MISSISSIPPI POWER & LIGHT COMPANY

SUBJECT: Grand Gulf Nuclear Station
Units 1 and 2
Docket Nos. 50-416 and 50-417
File: 0260/L-350.0
Transmittal of Corrections to SER
AECM-82/209

Attached for your consideration is a proposed revision to SER Chapter 17. This revision is provided to clarify the organizational and programmatic policies outlined in MP&L's Operational Quality Assurance Manual, MPL-TOP-1A, which has been accepted by the NRC.

LEGEND
 WORKING & QUALITY INTERFACE & DIRECT COMMUNICATION
 TECHNICAL & ADMINISTRATIVE AUTHORITY
 MANAGEMENT AUDITS
 -.-.- WORKING INTERFACE & COMMUNICATION
 -.-.- ON SITE/OFF SITE BOUNDARY LINE
 MP&L OPERATIONAL QUALITY ASSURANCE PROGRAM
 ORGANIZATION FIGURE 17.2-1

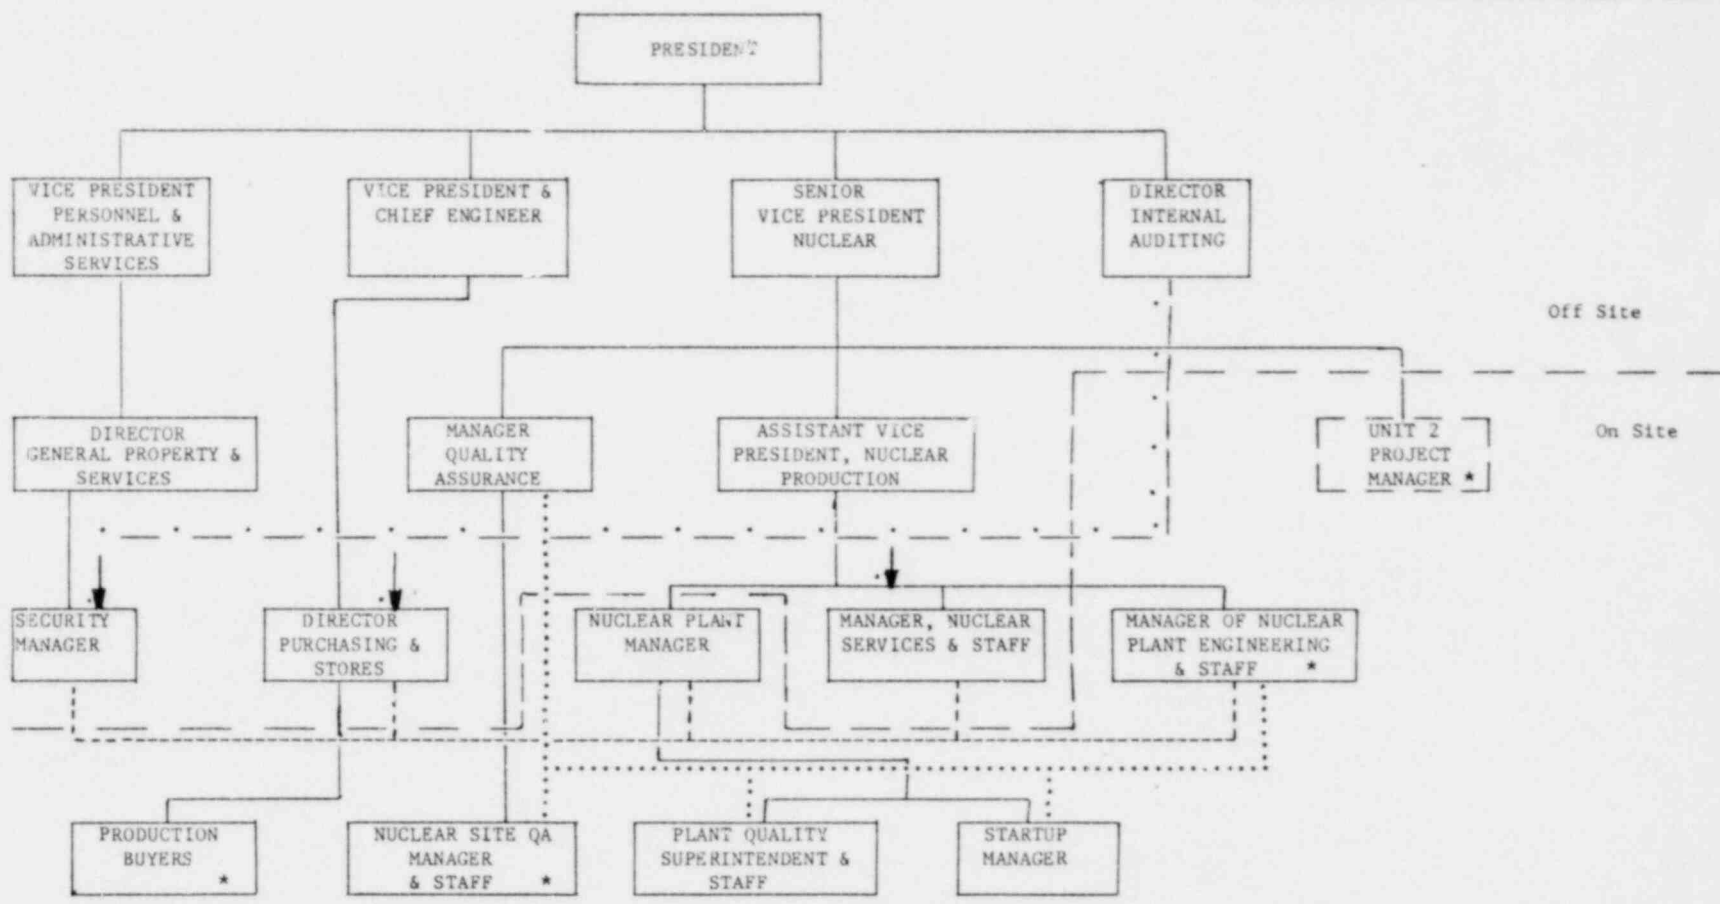
The structure of the organization responsible for the operation of Grand Gulf Nuclear Station, Units 1 and 2, and for the establishment and execution of the operational phase QA program is shown in Figure 17.1. The Senior Vice President - Nuclear, who reports to the President, has been delegated ultimate responsibility for the safe and reliable operation of the Grand Gulf Nuclear Station. He provides guidance and Corporate QA policies, goals, and objectives to the Manager of Quality Assurance.

The Manager of Quality Assurance reports directly to the Senior Vice - President - Nuclear and is delegated the overall responsibility for establishing, controlling, and verifying the implementation and adequacy of the QA program. He is assisted in carrying out his responsibilities by onsite (Nuclear Site Quality Assurance Manager and Staff) and offsite QA personnel.
